Request for Class II Permissive Change

FCC ID: BEJE2342TA

Please be notified that we, the undersigned, LG Electronics U.S.A., Inc. declare that the reasons for this Class II permissive change are as below:

1. To change the main IC

PCB and block compare

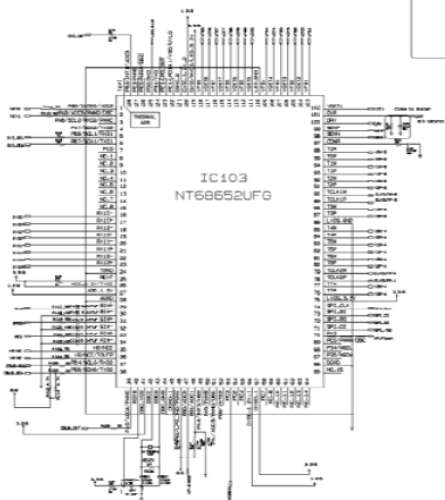
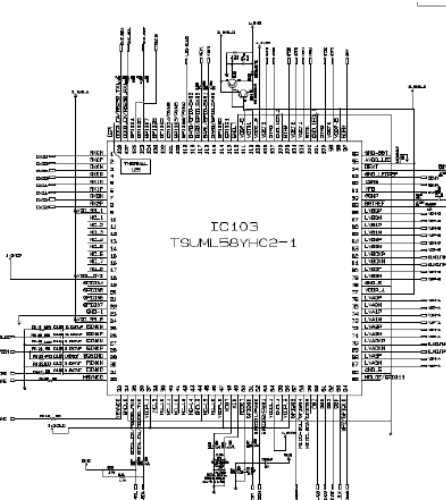
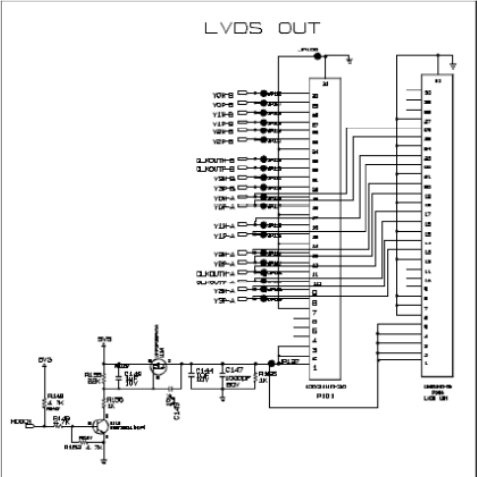
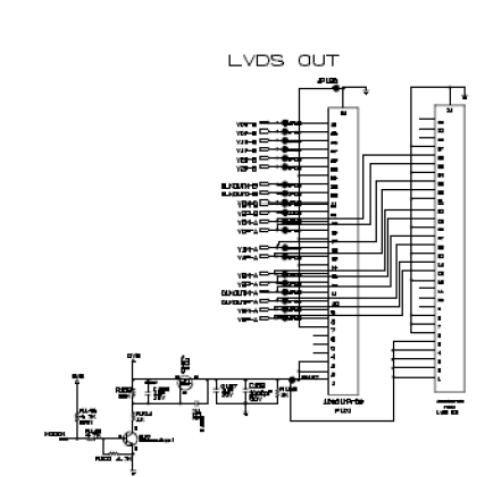
Maker	old	new	Change
PCB Photo			Different: 1. Main IC 2. LED drive
Block			Same : 1)Crystal :same 2) Resolution: same 3)Panel :same 4)Adapter : same

Circuit diagram compare-1

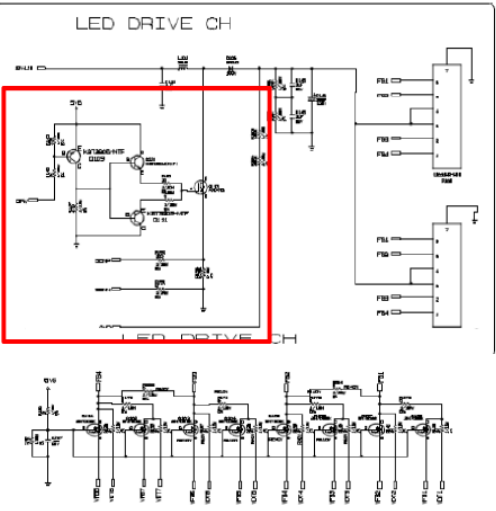
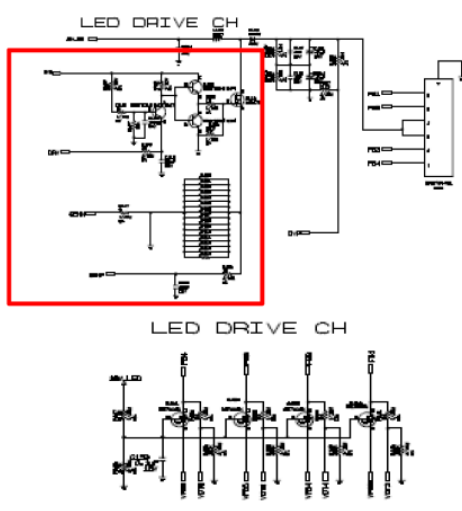
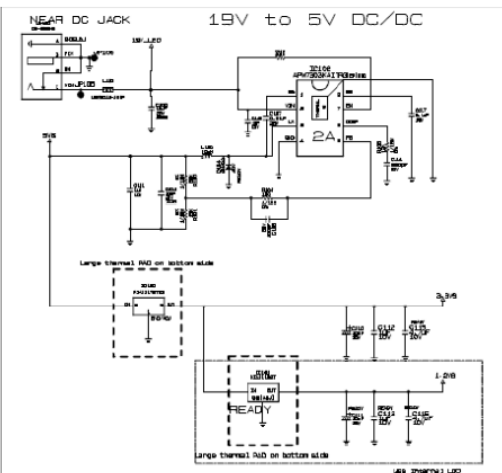
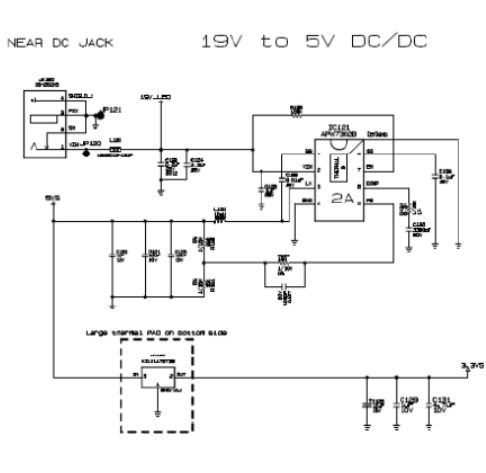
Maker	old	new	Change
Main IC circuit			1) Size: different 2) Pin No.: Same 3) Pin output: change 4) Maker different
LVDS out			Same

Circuit diagram compare-2

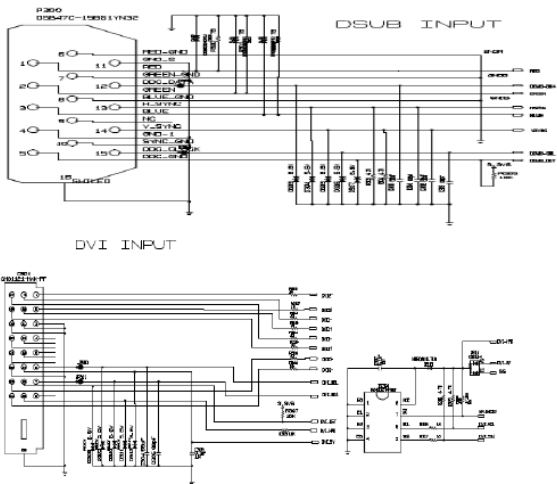
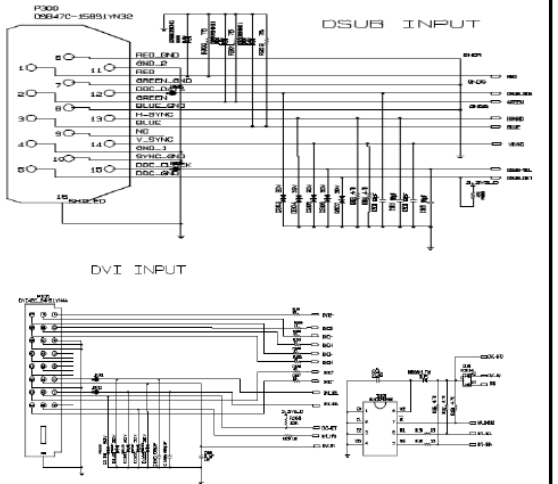
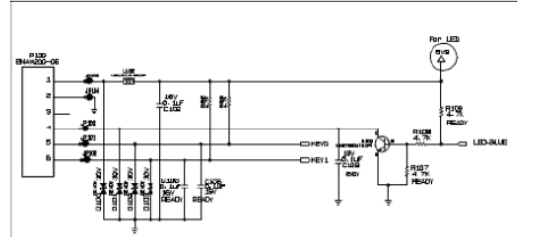
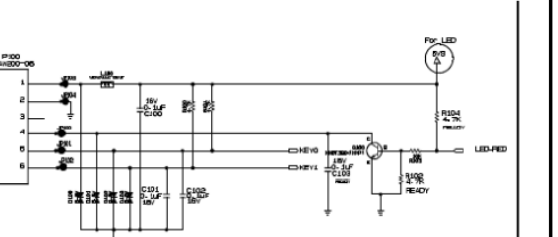
Maker	old	new	Change
LED drive CH			Change : Mos transistor →resistor Reason: cost down
19V to 5V			Same
